**ATTACHMENT 2  
BYLAW 17558  
FILE: LDA15-0370  
GLENORA**

**DESCRIPTION:** ZONING BYLAW AMENDMENT from (DC2) Site Specific Development Control Provision to (DC2) Site Specific Development Control Provision; GLENORA

**BYLAW 17558**  
**FILE: LDA15-0370**  
**GLENORA**

*Figure 1: Comparative tower floorplates, 900 m<sup>2</sup> versus 750 m<sup>2</sup> (red outline)*

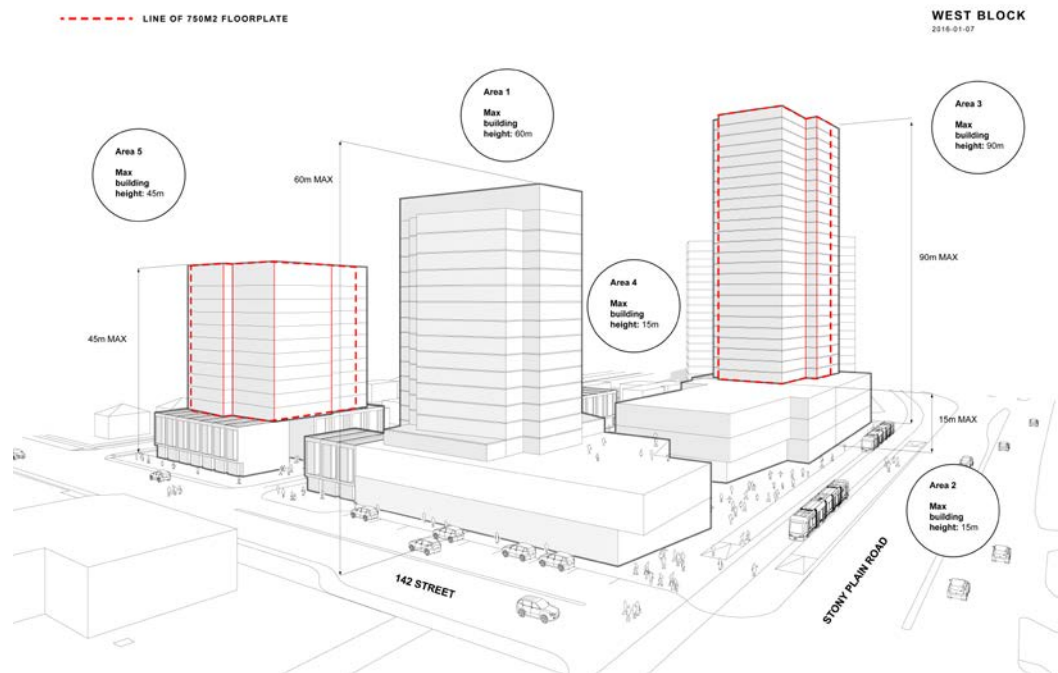
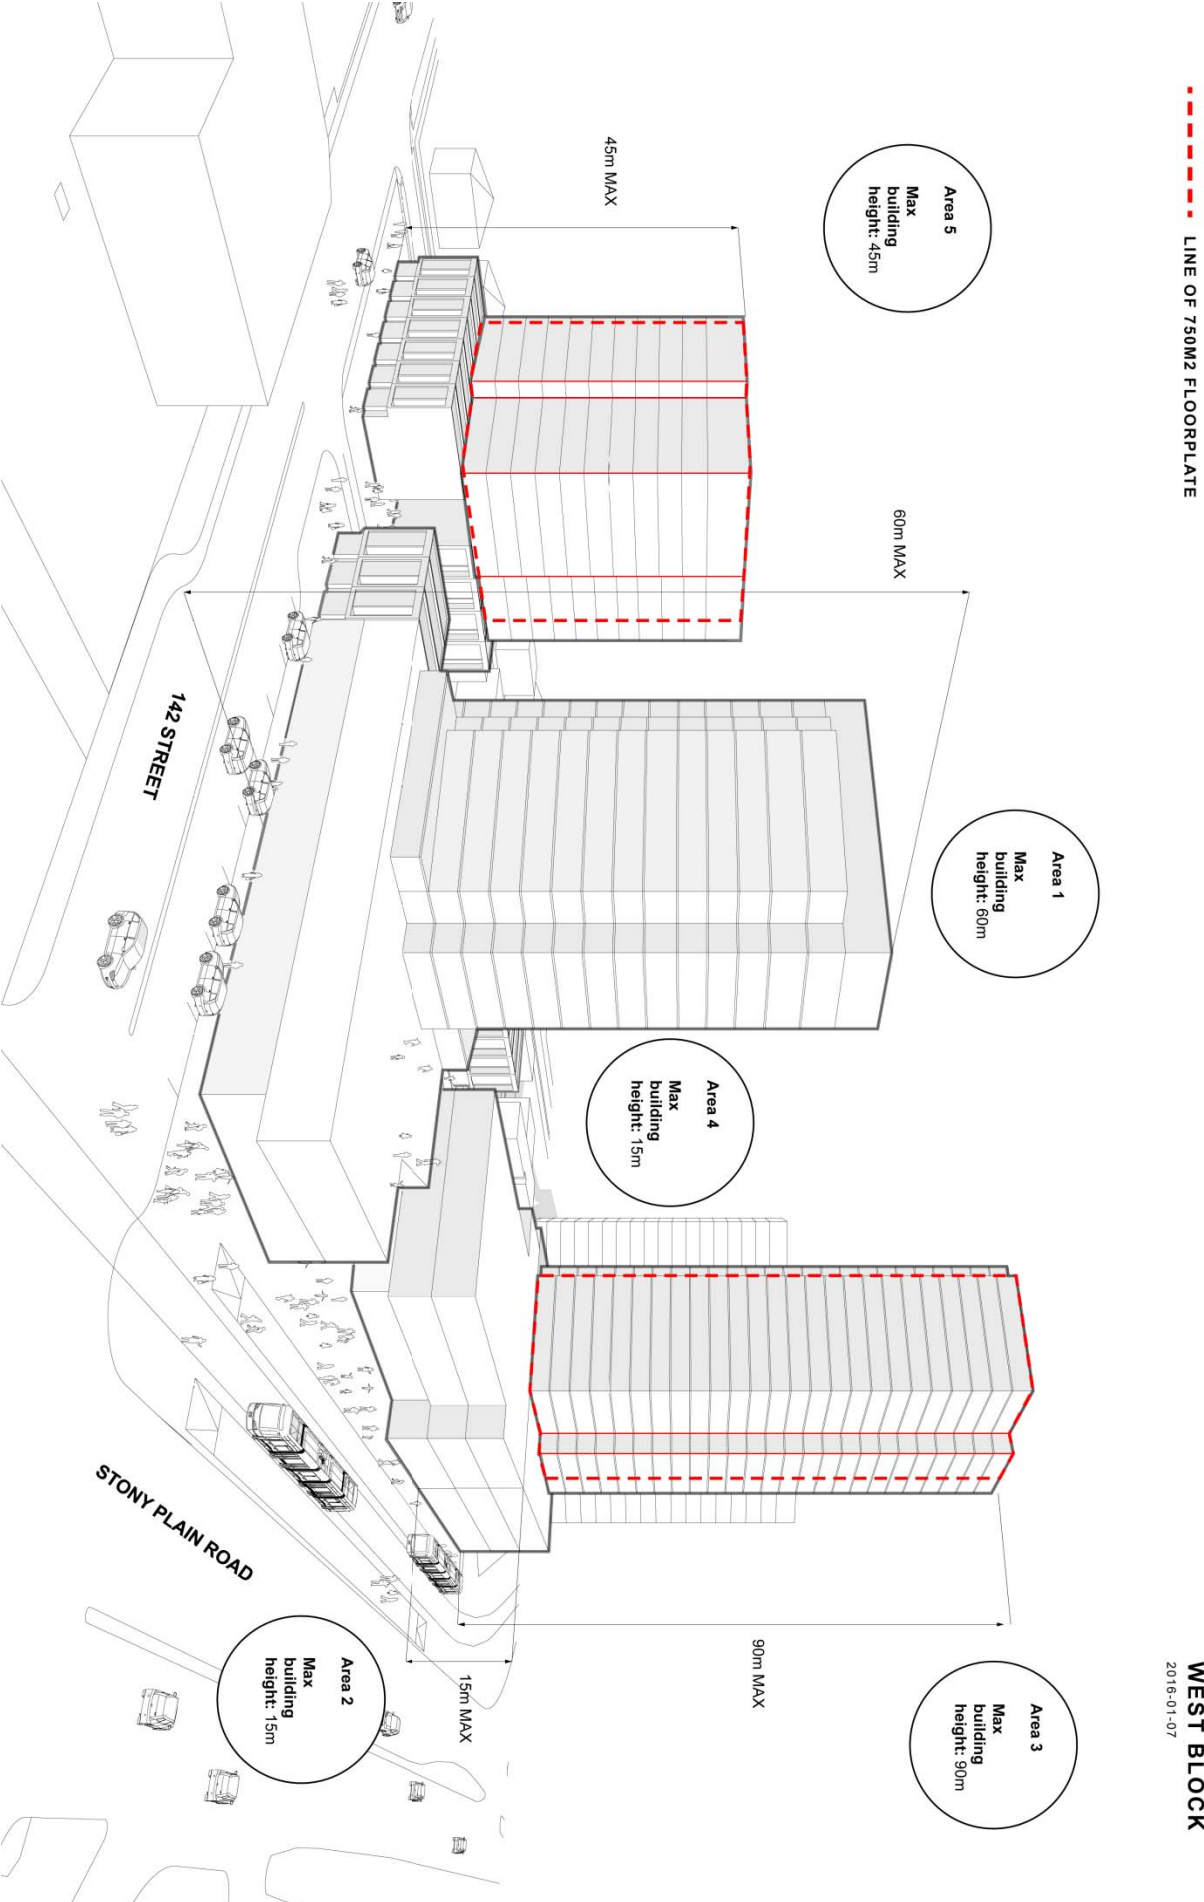
A 750 m<sup>2</sup> floorplate is considered a "slim" tower, and is the recommended size for towers in the Residential Infill Guidelines. The applicant has contended that a 900 m<sup>2</sup> floorplate is appropriate for areas outside the downtown core, does not create a negative visual or shadow impact, and is necessary to maintain the financial viability of the project. To support this case, the applicant has provided

the following renderings which illustrate the visual difference between a 750 m<sup>2</sup> and 900 m<sup>2</sup> floorplate. Administration used a massing model to explore the shadow impacts of a reduced floorplate and found that the difference in a 750 m<sup>2</sup> and 900 m<sup>2</sup> floorplate had a minimal impact on the amount of shadowing in the neighbourhood. However, the towers do not appear “slim,” and providing for a larger floorplate in this area may set an inappropriate model for future TOD developments outside the downtown.

*Figure 2: Comparative shadow impacts, approved DC2.833 (above) and proposed DC2 (below)*

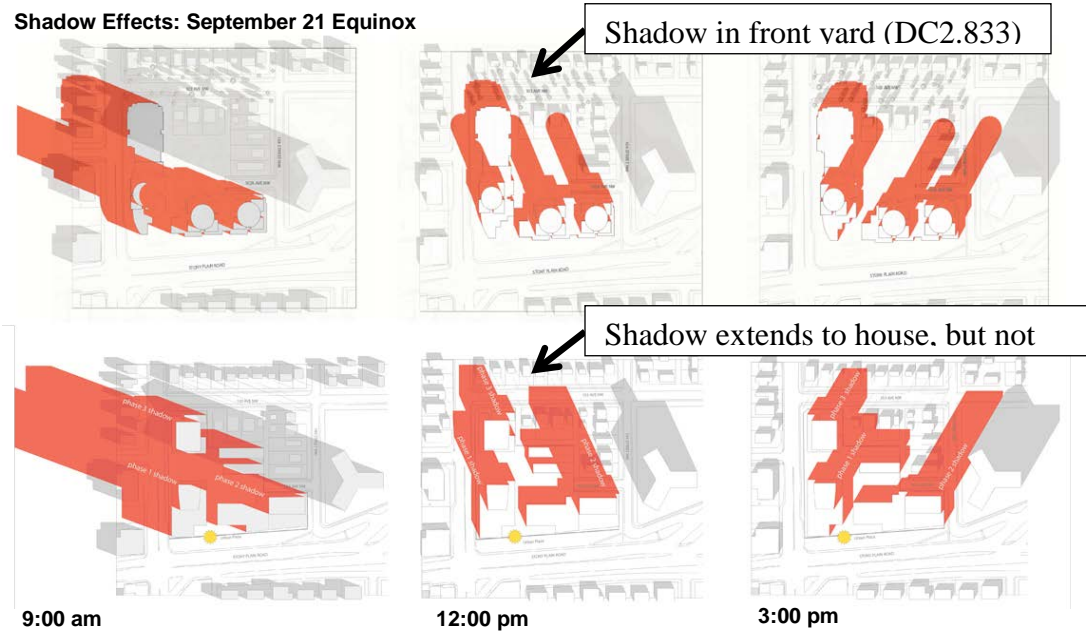
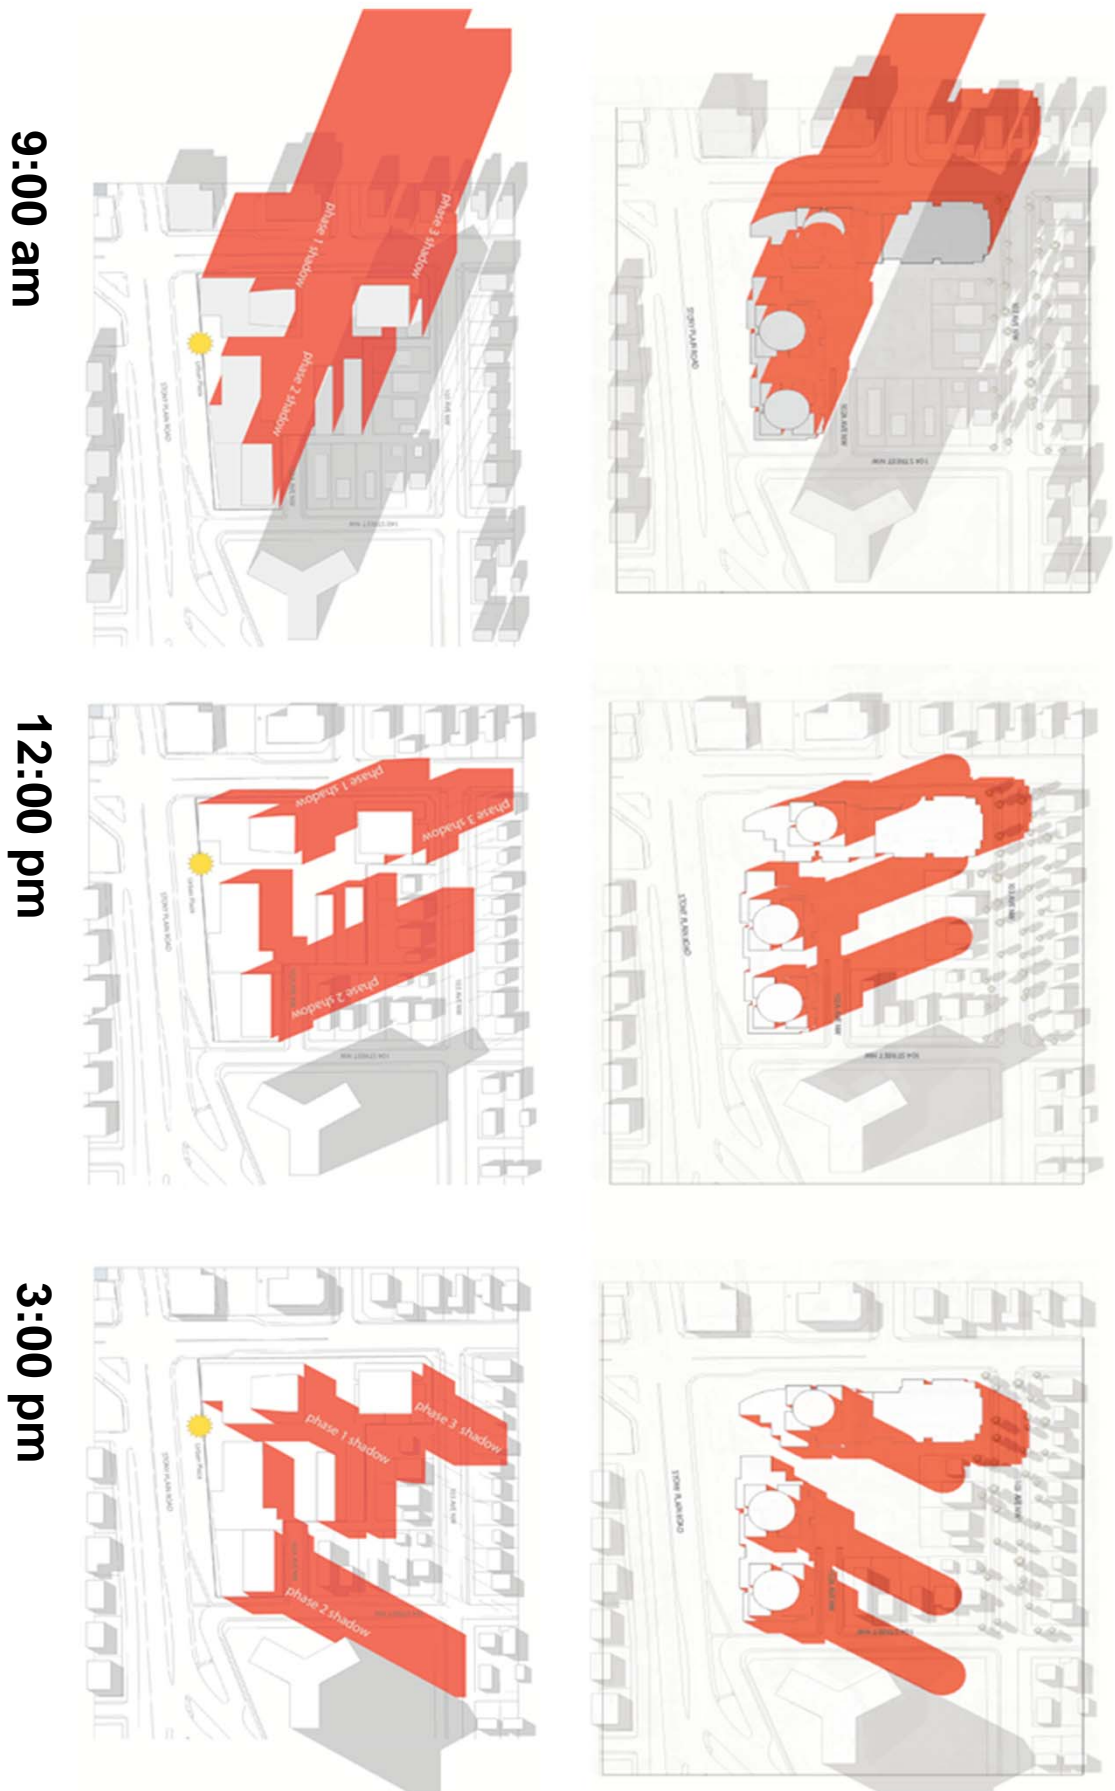
Administration also discussed the potential of reducing the proposed heights in Area 5 and Area 3 with the applicant, and used the massing model to explore the impact of different heights on shadowing. In Area 5, the height was initially proposed at 50 m, compared to the 21 m approved in DC2.833. The approved 21 m height resulted in shadows along the front lawns of the adjacent housing during the warmer months, while the proposed 50 m height created shadows that extended over the houses and into the backyards. Reducing the height to limit the shadow impact to the front yards was suggested to the applicant. The applicant reduced the height to 45 m, but contended that any height below 45 m was not financially viable and that when the shadows from the houses themselves were accounted for, a 45 m height was not functionally different than a lower height as the additional tower shadow would overlap with the house shadow. To support this proposal, the applicant provided a detailed sun-shadow study, which accounts for the existing building shadows. An illustration of the impact, compared to the approved tower shadowing, is provided below.

*Figure 3: Comparative 90 m, 80 m, 75 m, and 70 m heights for Area 3*

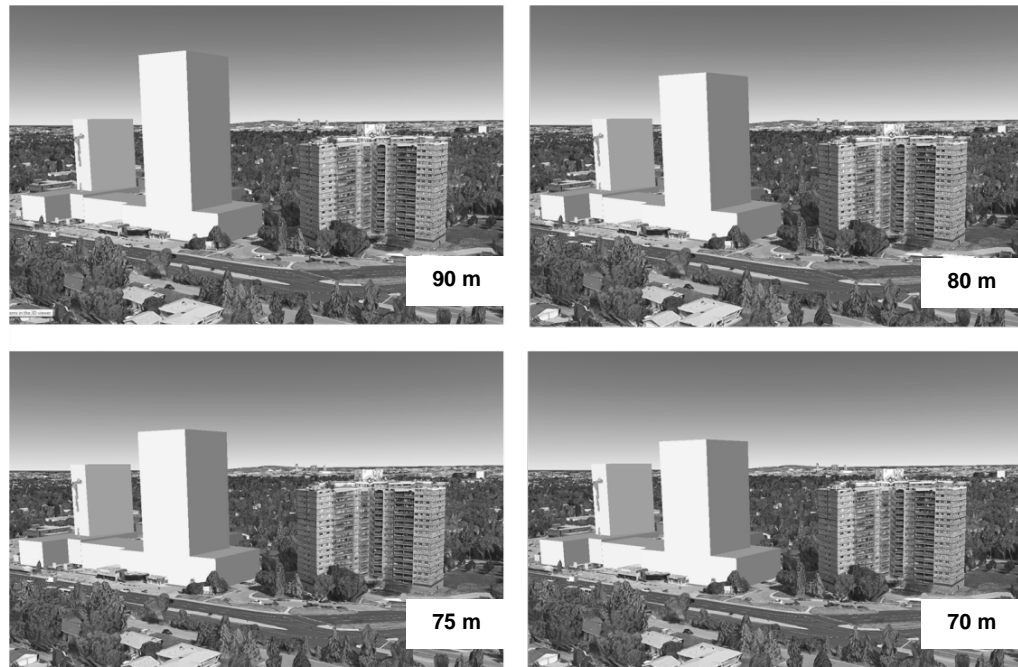
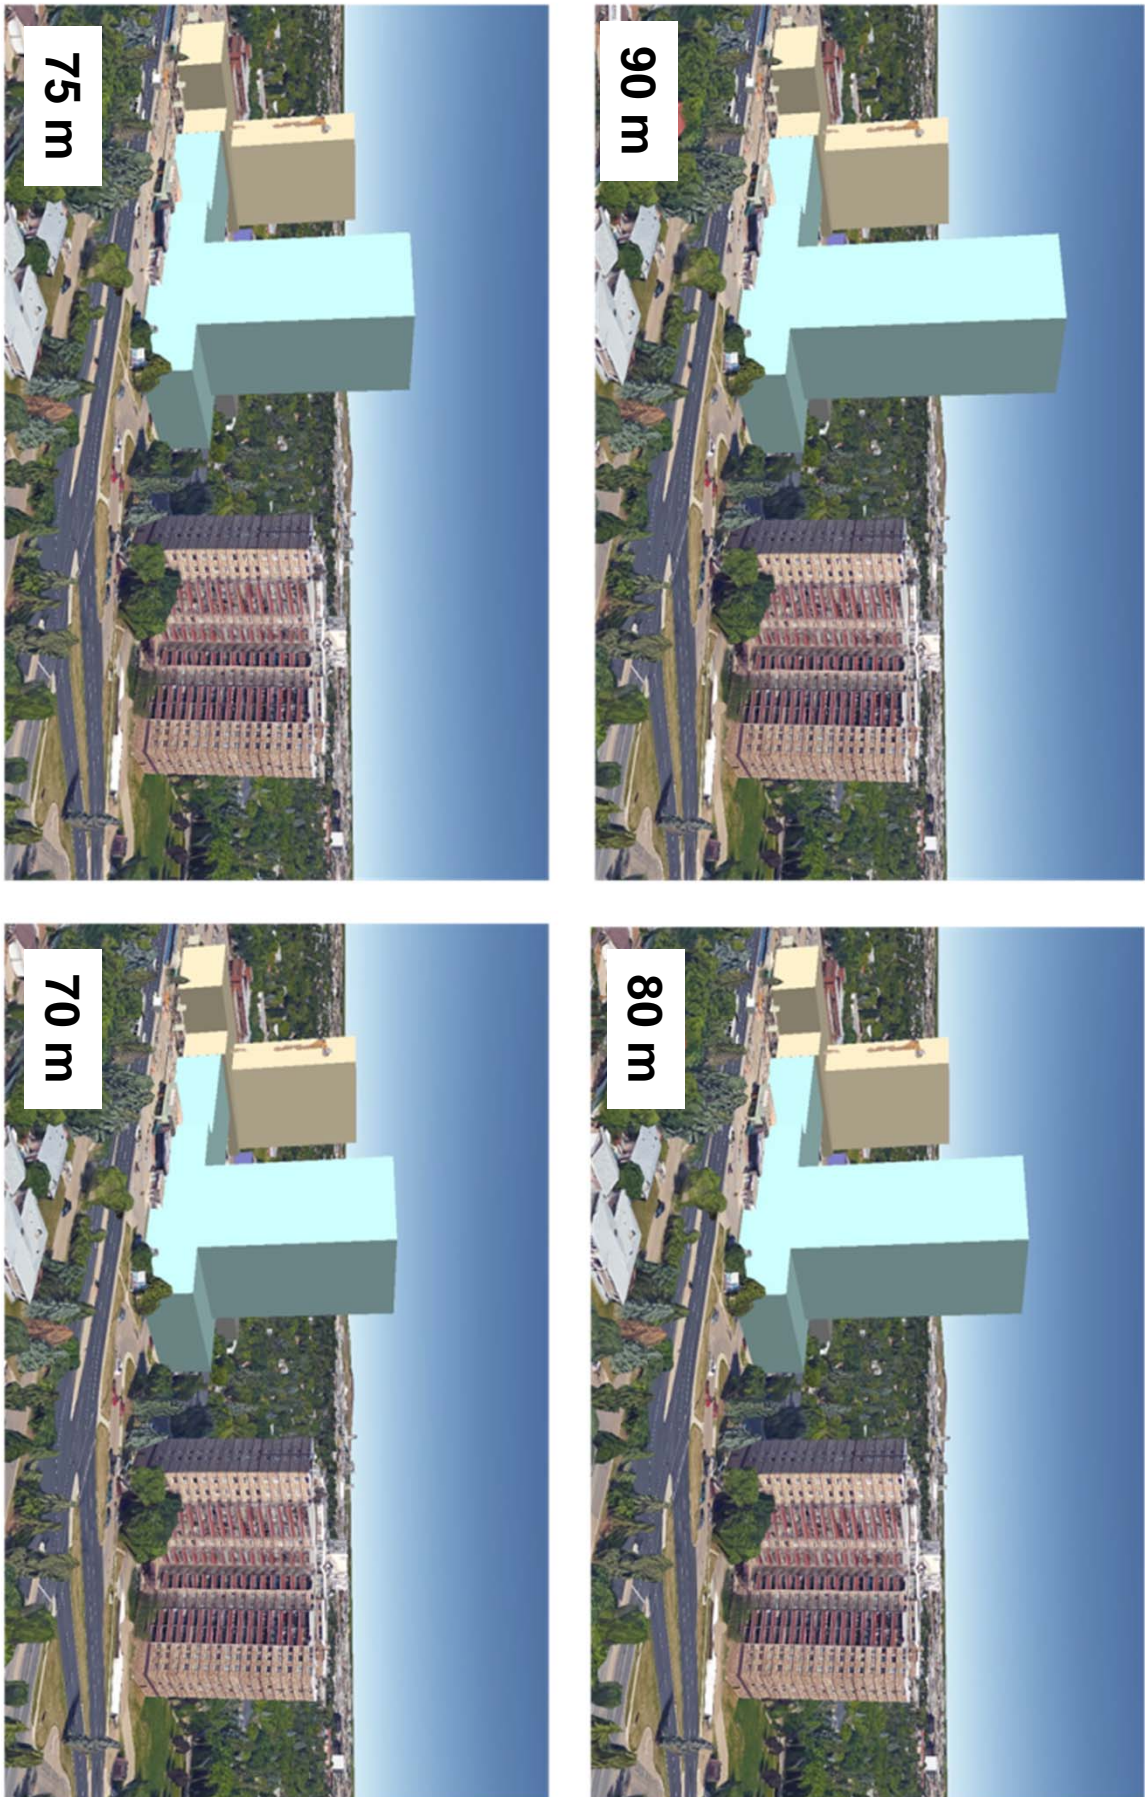
In Area 3, the proposed height increased from a 69 m maximum to a 90 m maximum. The sun-shadow study illustrated that the houses along 140 Street NW are impacted at both heights, but that the proposed increase in height did not result in shadows that extended past 103 Avenue in the warmer months. Although there were no physical shadow impacts because of the increased height, lower heights of 80 m, 75 m, and 70 m were modelled by Administration to review the visual impact of the tower. Based on these models, as illustrated below, it appeared that the tower height only began to appear reduced when the height was dropped to 70 m or lower. The applicant felt that this scale of a change, a potential 20 m decrease, was not financially viable, given the constraints of the site and the inability to place this height in a different location.

*Figure 4: Angular Plane Assessment from property line and front yard setback, proposed DC2*

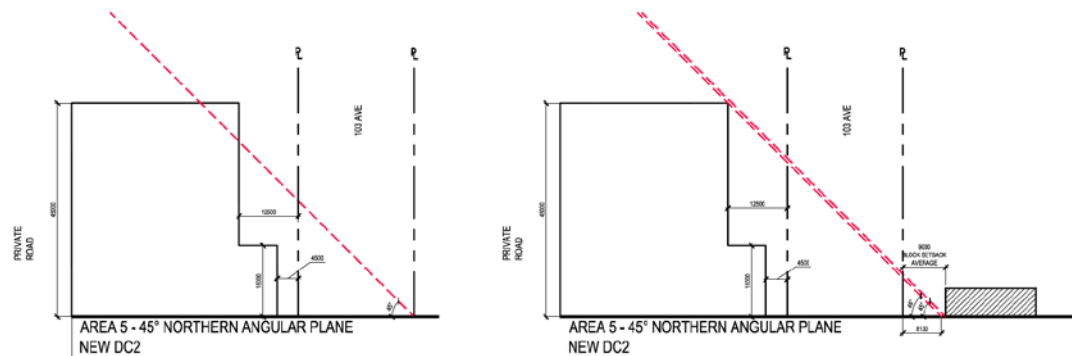
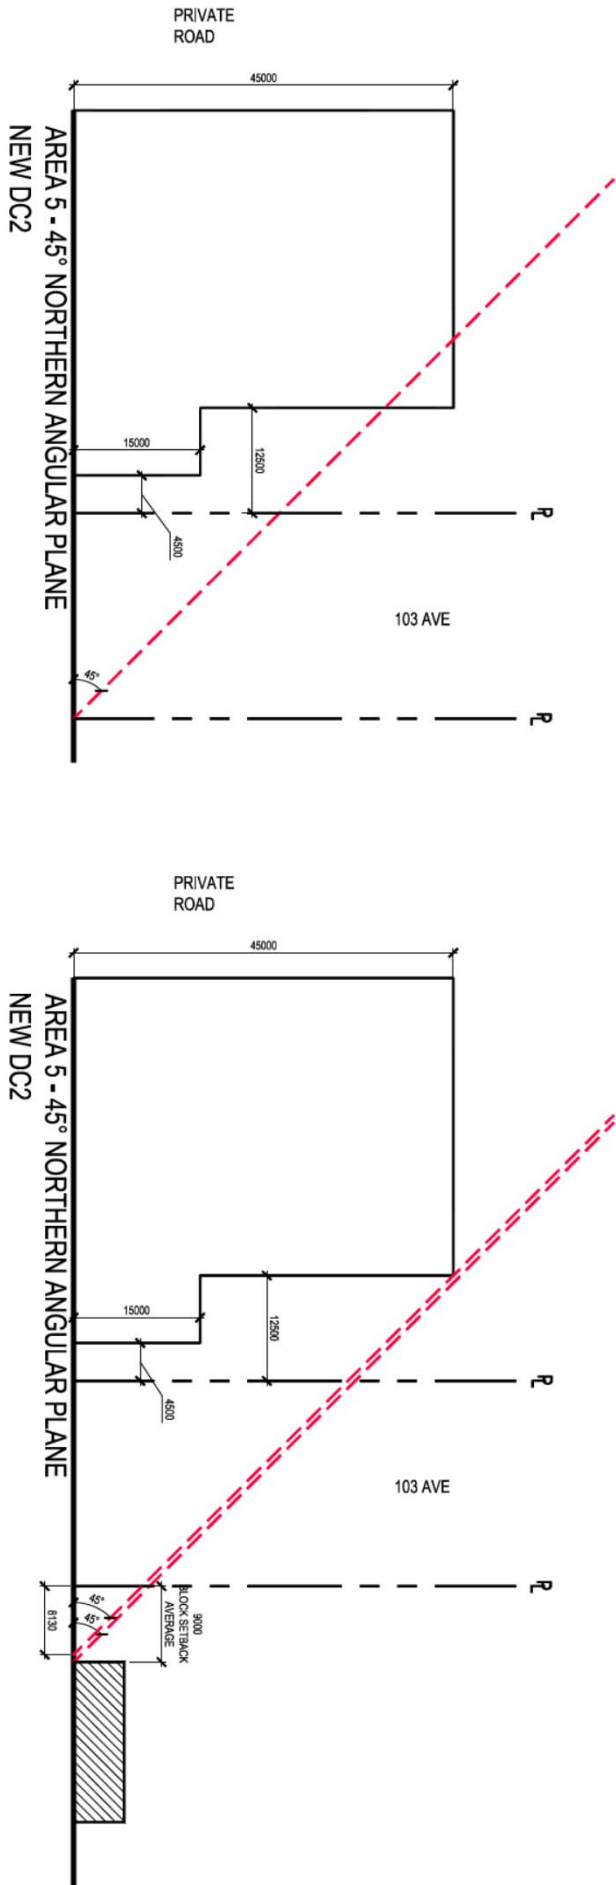
Providing additional setbacks and stepbacks were also explored with the applicant, particularly in Area 5 which is directly opposite single-detached housing. These features can reduce the perceived impact of a taller building by placing the tower portion within a 45 degree angular plane, as measured from the property line. The applicant contends that additional stepbacks are not possible, as there are significant cost restraints to this style of building. To support their proposal, the applicant provided additional modelling demonstrating how the proposed building fits within the angular plane when measured from the average front yard setback, as illustrated below. Based on the applicant's modelling, the proposed DC2 would result in a building that appears large to people travelling along 103 Avenue NW or the adjacent sidewalks, but provides enough separation through front yard setbacks to minimize this effect on residents.
